**SUBJECT:** **R.E. Ginna Nuclear Power Plant**  
Docket No. 50-244

Response to Request for Information Re: License Amendment Request:  
Emergency Core Cooling System (ECCS) Accumulator Boron Concentration  
Verification Frequency

**Attachment (1)**

Figure (1)

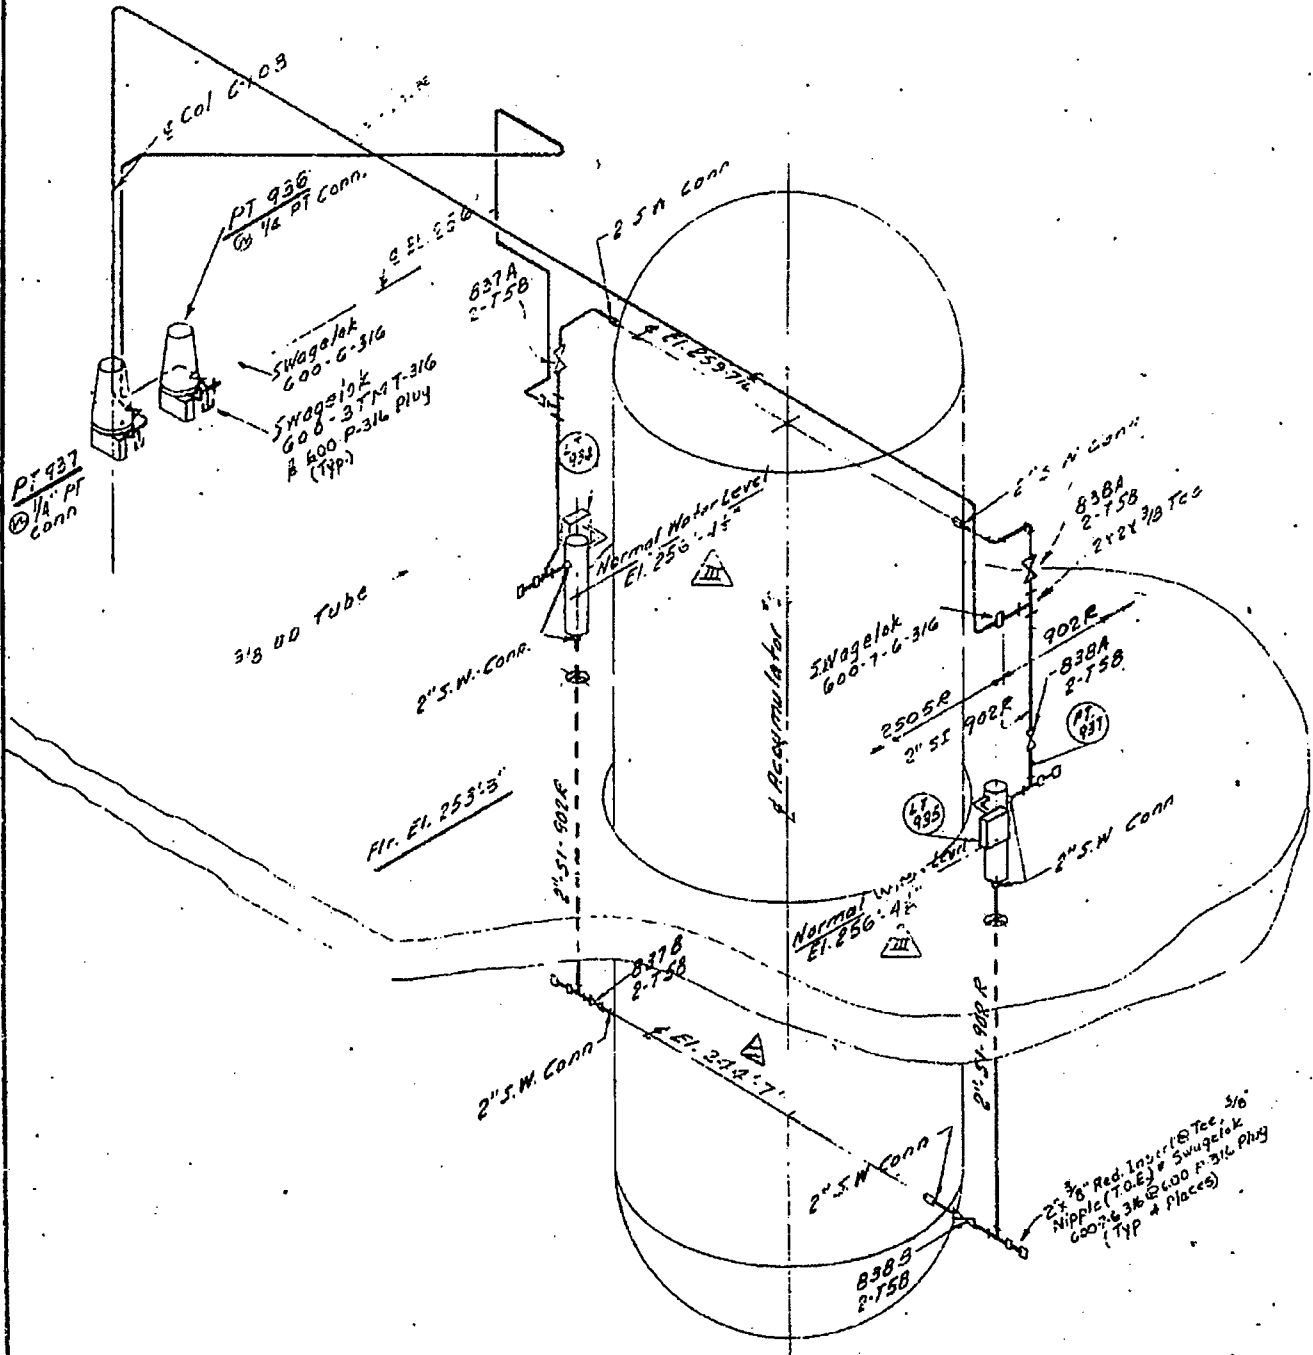
**Question 5: Provide a more detailed description of the level instrumentation and how the instrumentation correlates levels of the liquid in the accumulator to corresponding volumes. In order to understand how the system works, physical arrangements of the different components of the system should be described.**

The attached as built ECCS Accumulator drawing, Figure (1), illustrates the relationship between the level transmitters (LT-934/935) and the ECCS Accumulator. The level transmitters are buoyancy displacer type transmitters and will not begin to indicate until the associated accumulator reaches a level corresponding to the bottom of the sensing unit. The Span of this unit is scaled to 0% - 100% of the 14 inch span of the unit. Whereas, the distance from the bottom instrument tap to normal water level is ~ 141 inches (Reference: Ginna Design Analysis DA-NS-97-051, Calculation of SI Accumulator Water Level as a Function of Water Level

Indication). Therefore, this could be considered a narrow range instrument, which provides increased sensitivity to detect inleakage.

Using the above information, the top and bottom of the scale would correspond to the following volumes.

$$8311 \text{ gal}/50\% \text{ level} - (50\% * 6.25 \text{ gal}/\%) = \sim 7998.5 \text{ gal at } 0\% \text{ level}$$

$$8311 \text{ gal}/50\% \text{ level} + (50\% * 6.25 \text{ gal}/\%) = \sim 8623.5 \text{ gal at } 100\% \text{ level}$$
